5 VOLT FlashFile™ MEMORY

28F004S5, 28F008S5, 28F016S5 (x8)

SPECIFICATION UPDATE

Release Date: February, 1999

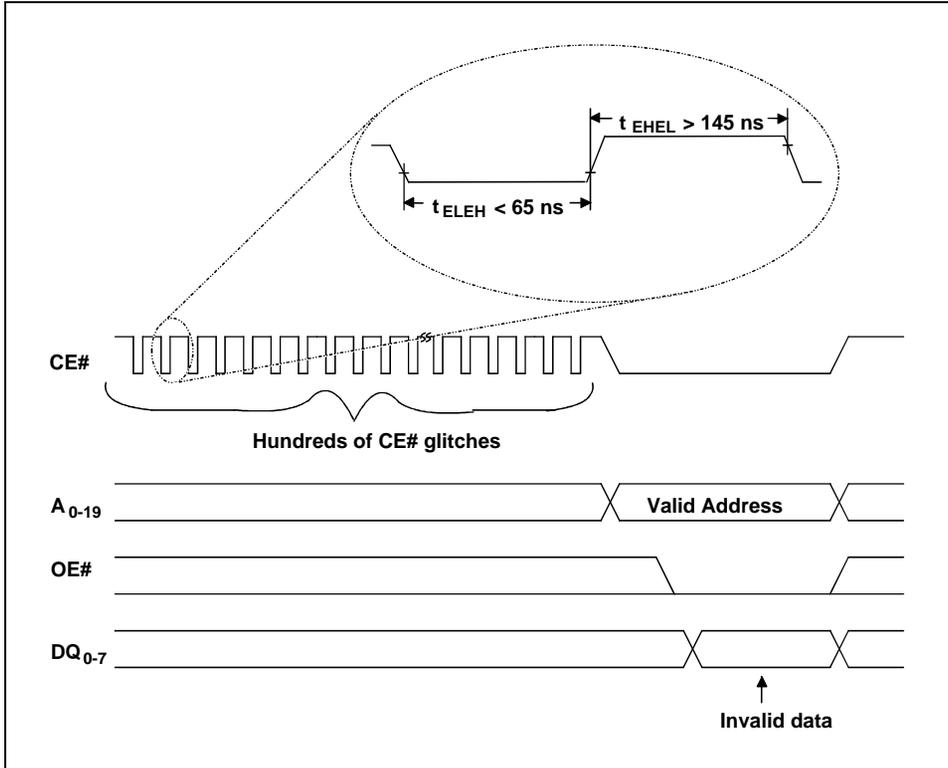
PROBLEM: For the 8- and 16-Mbit devices that are effected by this erratum, the block unlocking security feature is currently nonfunctional. Attempts to unlock blocks, using the clear block lock-bits command sequence, may cause subsequent program and/or block erase failures. The failure is seen as a device protection error in the status register.

IMPLICATION: Block unlocking feature is disabled. This erratum effects the following command, Clear Block Lock-Bits. Locking blocks using the Set Block Lock-bits command (while RP# is equal to 12 volts) is still supported.

WORKAROUND: To prevent accidental software block lock-bit clearing, Intel permanently sets the master lock-bit during the test flow. This disables the ability to lock and unlock blocks via software only with RP# = V_{IH} . Block locking and unlocking requires 12V on the component's RP# input when the master lock-bit is set. Don't execute the clear block lock-bits command sequence when 12V is applied to RP#. Instead, simply override the block locking mechanism by applying 12V to RP# to enable program/erase operations that target locked blocks.

If data security is of utmost importance, lower V_{PP} voltage equal to or less than V_{PPLK} during normal operations. With V_{PP} equal to or less V_{PPLK} , the device is protected against all data manipulation operations.

A Long Series of CE# Glitches May Induce an Invalid Read

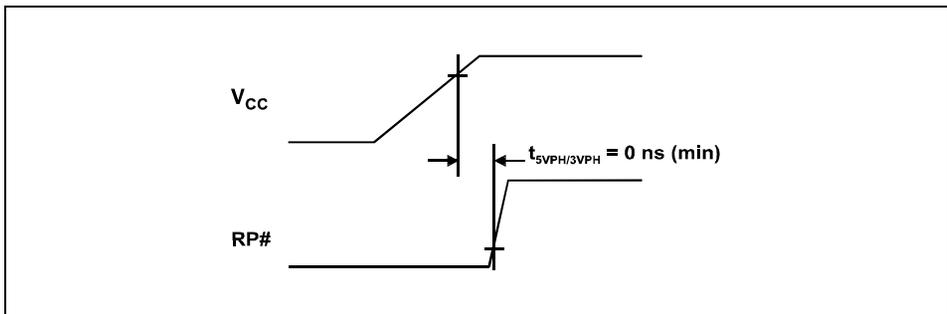
PROBLEM: A noisy CE# control signal may cause an invalid read. This erroneous read only occurs after the device has received over one hundred consecutive short CE# glitches ($t_{EHL} < 65 \text{ ns}$) with CE#-high time (t_{EHEL}) greater than 145 ns (see the figure below, *A Long Series of CE# Glitches May Induce an Invalid Read*).

After valid data is read, the device must receive another series of CE# glitches (typically over one hundred) to induce an invalid read.

Add system logic to prevent CE# glitches such as latched CE# control logic or pullup/pulldown resistors to the address bus.

If the device receives over one hundred consecutive CE# glitches, issue a Byte Write command and program FFh to any location before executing a read operation. Programming FFh will not alter stored data, but it will give the component sufficient time to prepare for the read operation.
